N4902A-01-S

S E R V I C E N O T E

Product Number: N4902A , Serial BERT

POSSIBLE FIRE HAZARD

The following photo illustrates the layout of the instrument. It shows the polypropylene molding, the graphics card and the starting point of the fire.

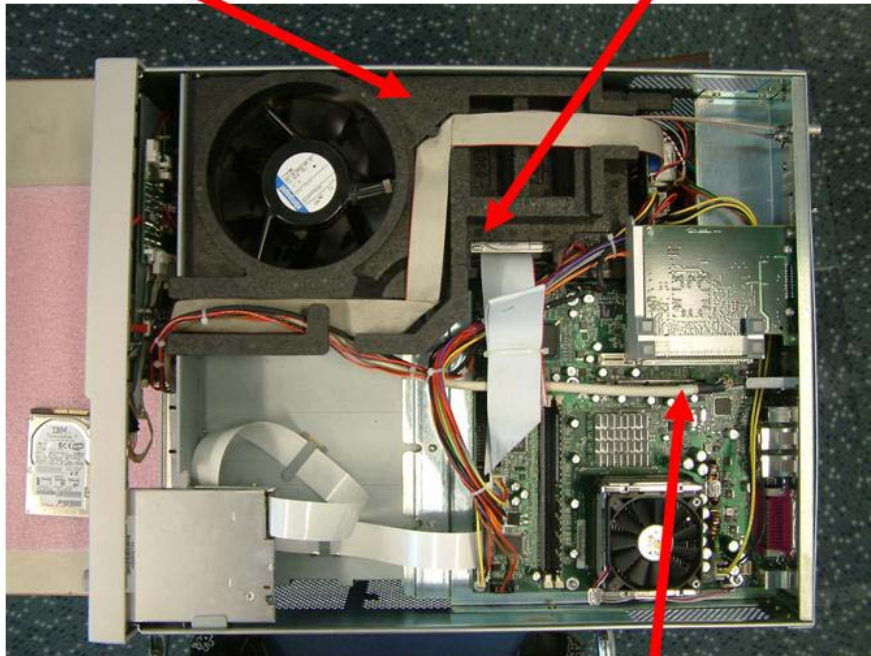
A surface-mount ceramic capacitor suffered physical stress during the manufacturing process, leading the capacitor to crack. During operation this crack placed stress on the internal structure of the capacitor, and caused the plates to short together. (The plates are separated by very little space, made up of very thin insulators.) This caused the capacitor to have very low residual impedance, resulting in a very high current conducted through the capacitor and the 12V path on the motherboard for some period of time. The low impedance didn't lead to a current high enough for blowing the fuse. Therefore the higher current was available long enough to create a very high temperature ($T > 300^{\circ}\text{C}$). The high temperature ignited the polyurethane molding used to conduct the airflow for cooling through the instrument.

Start of Fire

Graphics Card

The countermeasure for this issue is to exchange the graphics cards. The new graphics cards are produced with an improved manufacturing process eliminating the risk of micro cracks and have additional fusing to protect the 12V path. The graphics card can be exchanged by Agilent authorized personnel only.
